Work Order ID 110855

Item Name: Aft Crosstube - High

DRAWING NO. D412-664-243	TITLE CROSSTUBE ASS'Y (412 HI AFT)	REV. E	<b>DART AEROSPACE LTD ENGINEERING ORDER</b>		D.E.O. NO. D412-664-243-E-2	SHEET NO. SHEET 1 OF 1	SCALE NTS
DRAWN <i>Q</i>	CHECKED <i>AS</i>	MFG. APPR. <i>R</i>	APPROVED <i>MP</i>		DE APPR. <i>#</i>		
DATE 11.09.07	DATE 11.09.19	DATE 11.09.19	DATE 11.09.19		DATE 11.09.19

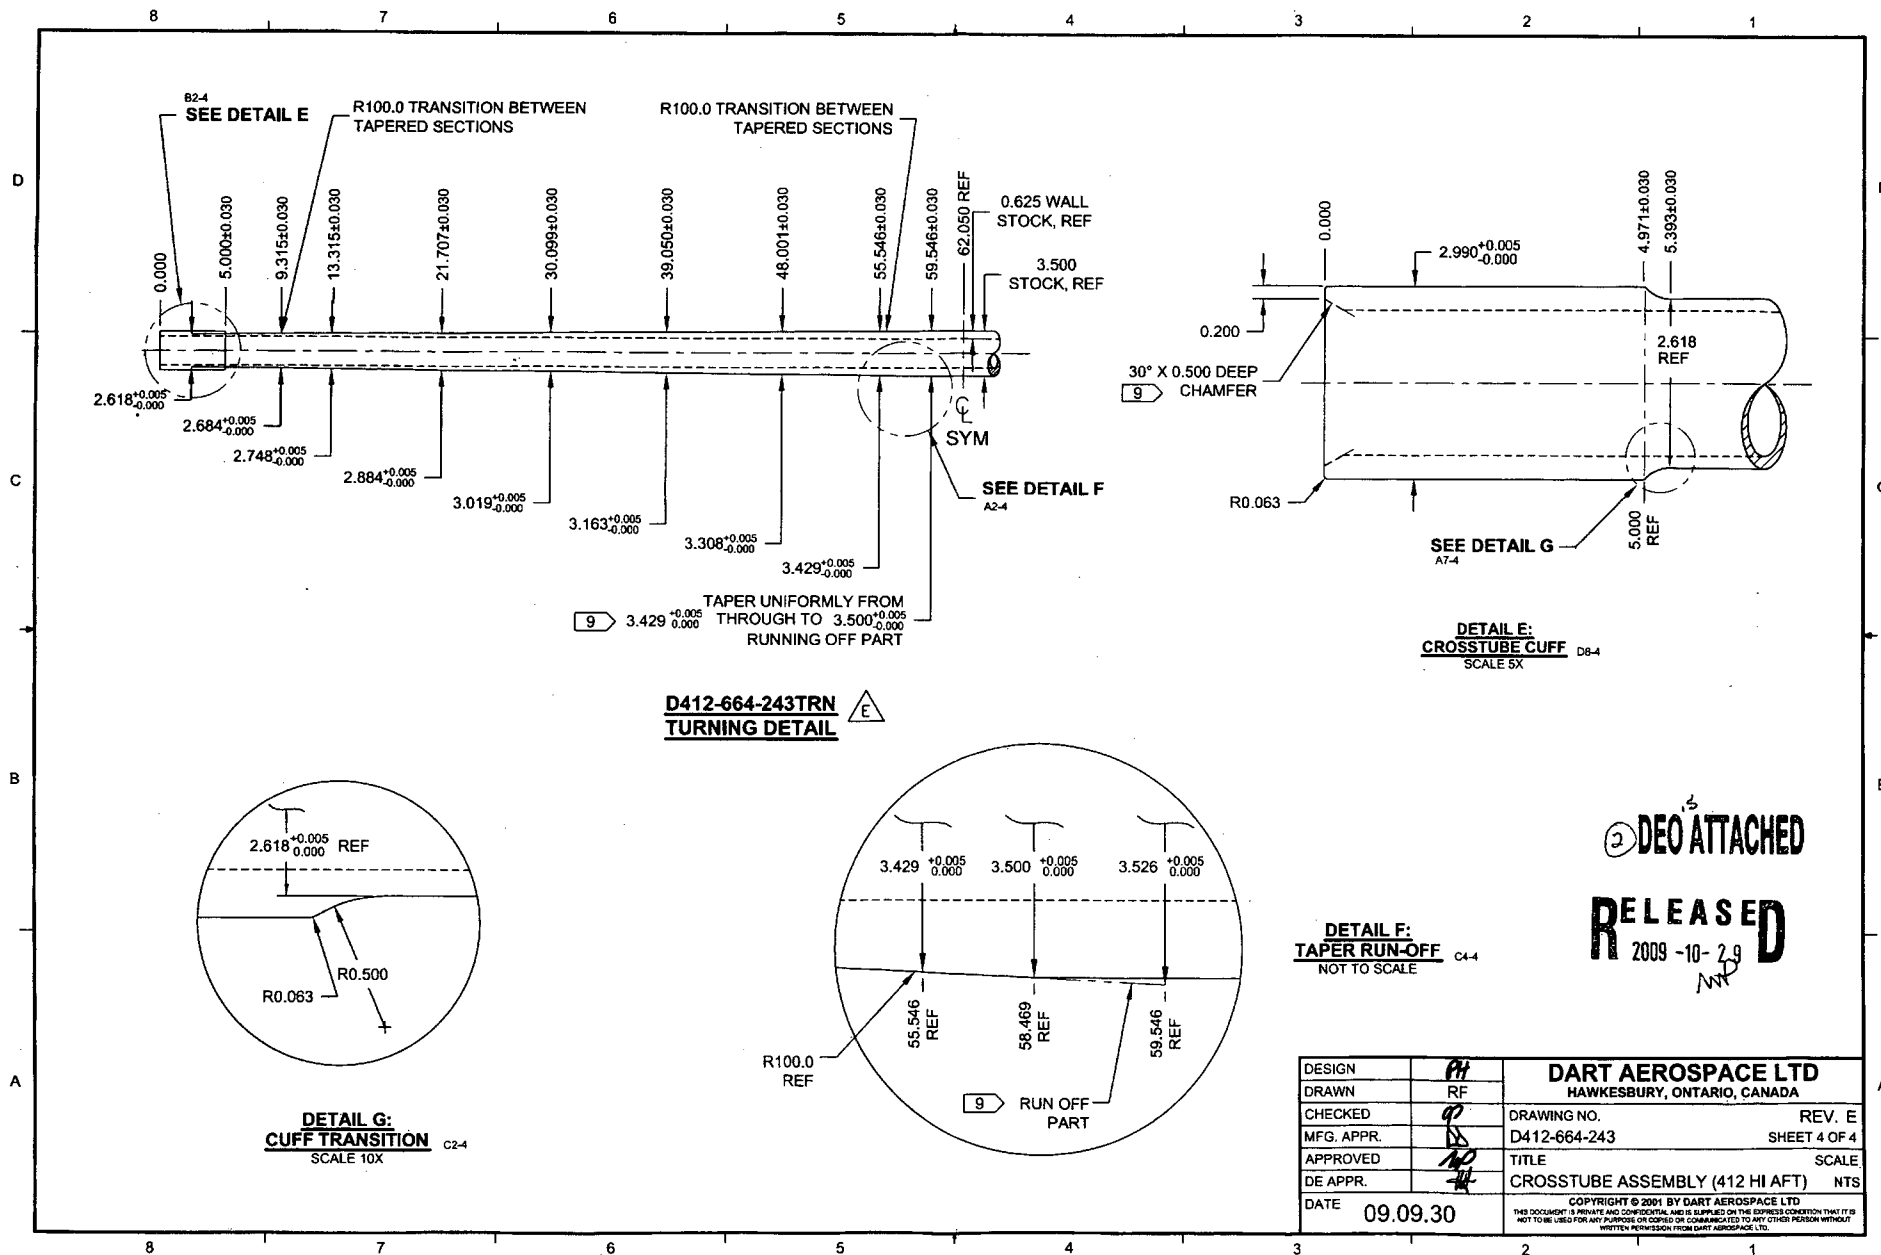
REPLACE MAGNOBOND WITH 3M DP460 SCOTCH-WELD EPOXY ADHESIVE

NOTE 12 & 16, SHEET 1 IS AMENDED AS FOLLOWS:

DRAWING NO. D412-664-243	TITLE CROSSTUBE ASSEMBLY (412 HI AFT)	REV. E	DART AEROSPACE LTD ENGINEERING ORDER	D.E.O. NO. D412-664-243-E-4	SHEET NO. SHEET 2 OF 3	SCALE NTS
DRAWN 97	CHECKED	MFG. APPR.	APPROVED	DE APPR.		
DATE 12.08.21	DATE 12.08.27	DATE 12.08.29	DATE 12.08.29	DATE 12.08.29

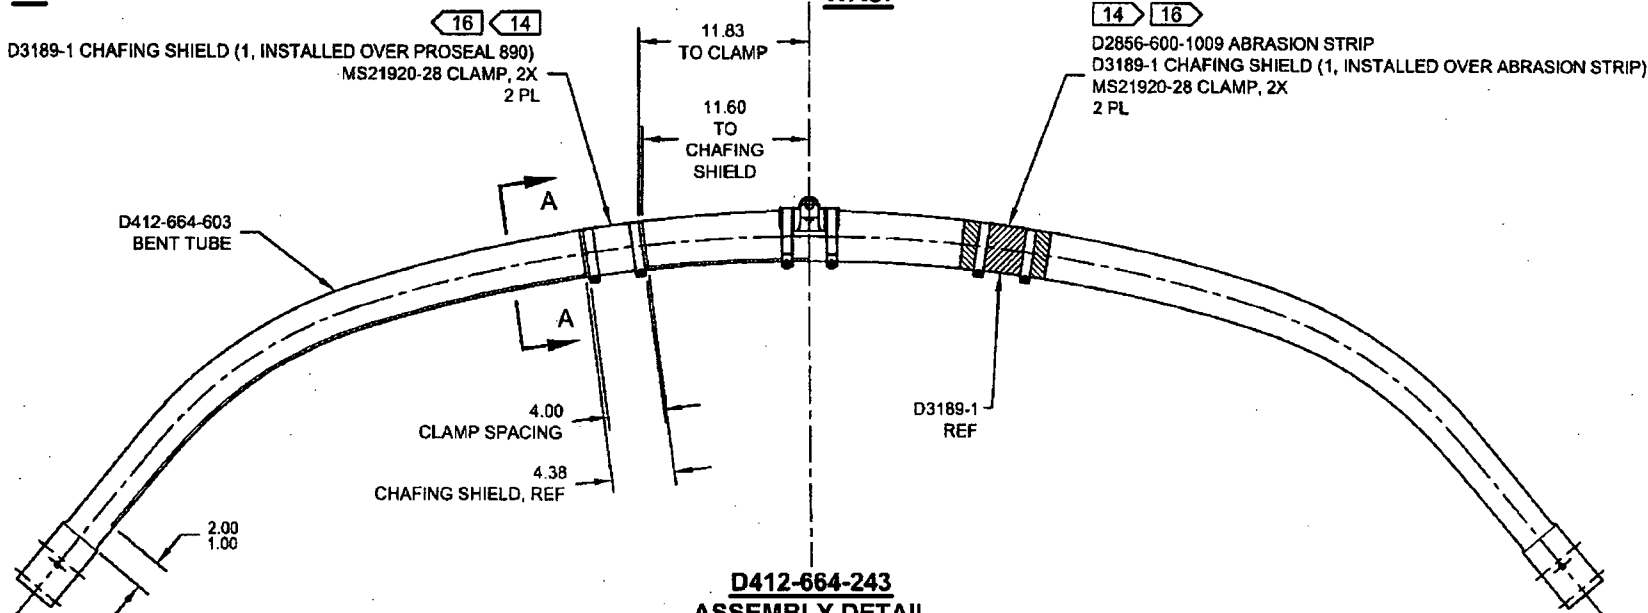
**NOTES 2, 14, AND 16 ON SHEET 1 ARE AMENDED AS FOLLOWS:**

**WAS:**

- 2) FINISH: CHEMICAL CONVERSION COAT PER DART QSI 005 4.1  
PRIME INSIDE AND OUTSIDE PER DART QSI 005 4.2  
PAINT OUTSIDE PER DART QSI 005 4.2
- 14) INSTALL D2856-600-1009 ABRASION STRIPS WITH A 0.13 REF GAP ON BOTTOM SIDE OF CROSSTUBE PER QSI 035.
- 16) TORQUE CLAMPS 80 TO 100 IN-LB. ENSURE AT LEAST 1.5 THREADS SHOWING IN SAFETY AND THAT NUT HAS NOT BOTTOMED-OUT AFTER TORQUING.

**D412-664-243  
ASSEMBLY DETAIL**

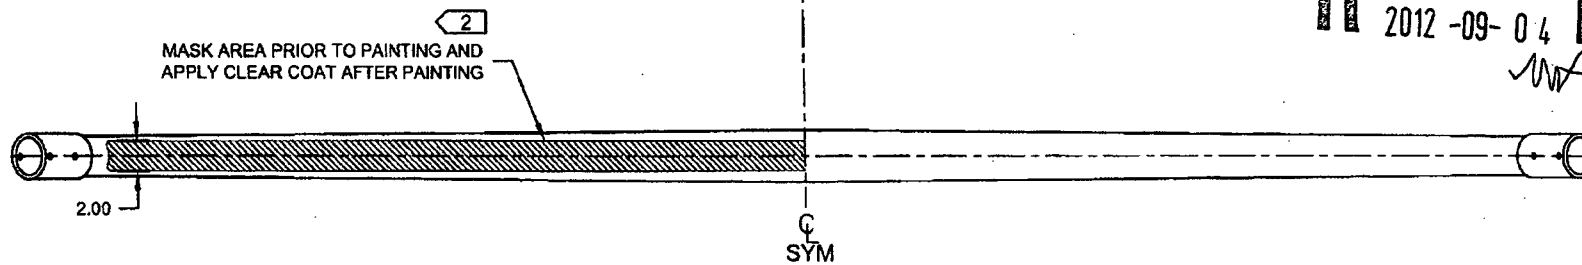
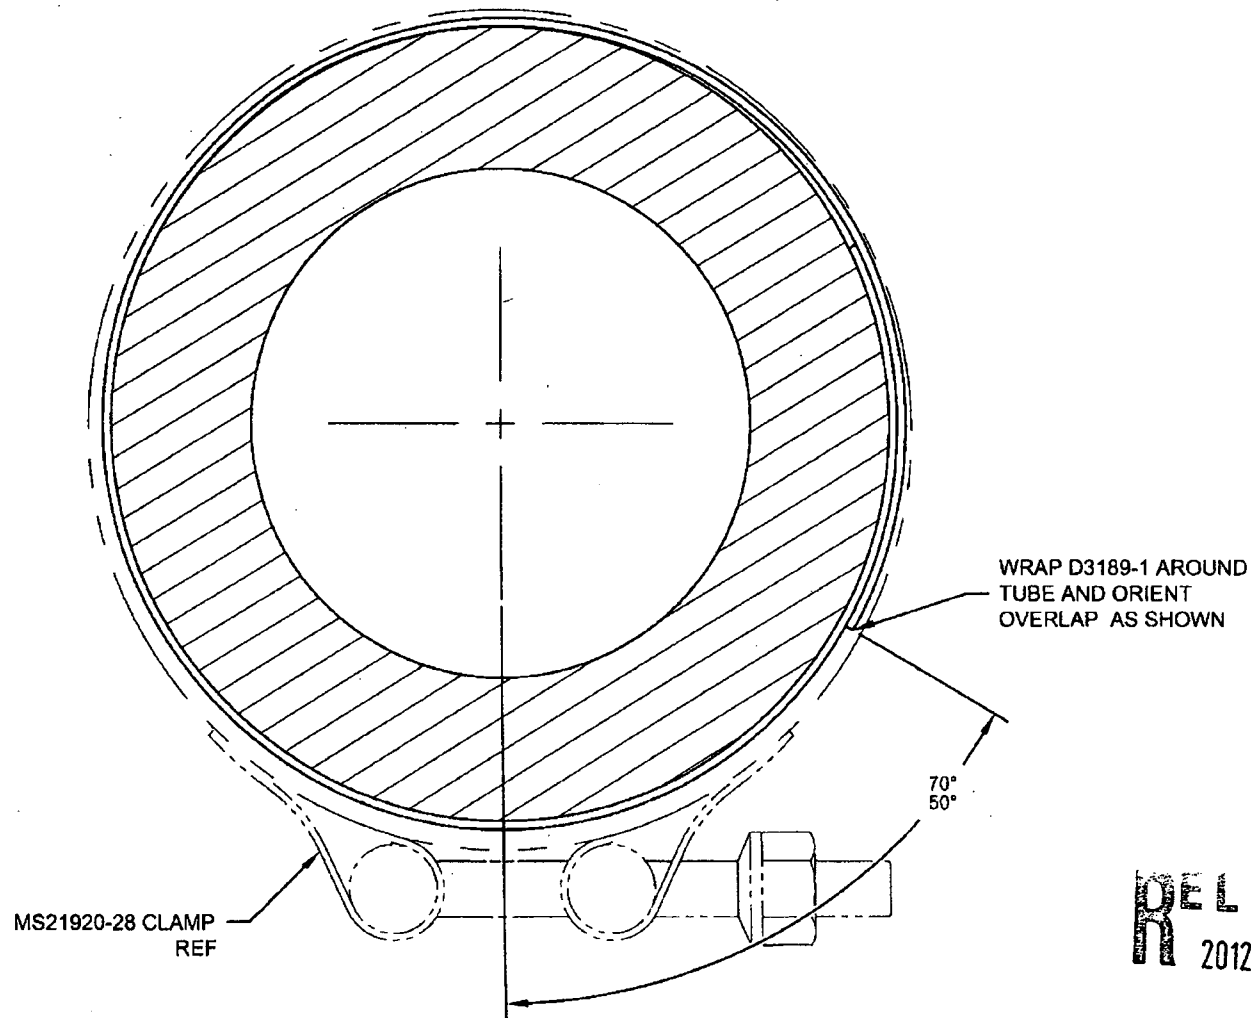
D2856-600-1009 ABRASION STRIP  
D3189-1 CHAFING SHIELD (1, INSTALLED OVER ABRASION STRIP)  
MS21920-28 CLAMP, 2X  
2 PL

CRUSHING OF D412-664-243

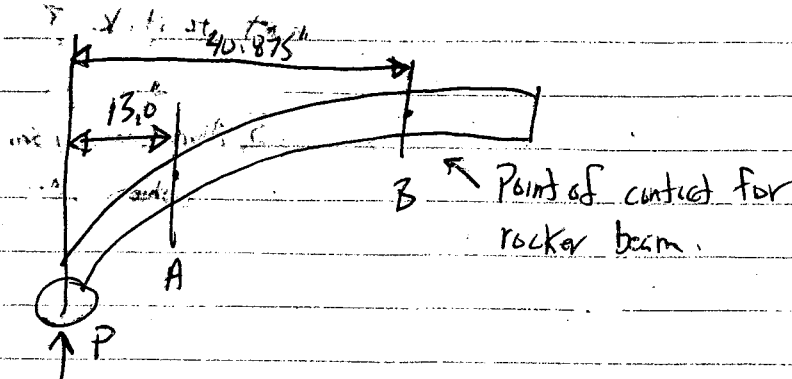
Acceptability of 8% CRUSHING AT END OF BEND

Point A:  $OD_1 = 2.961''$ ,  $OD_2 = 2.522''$
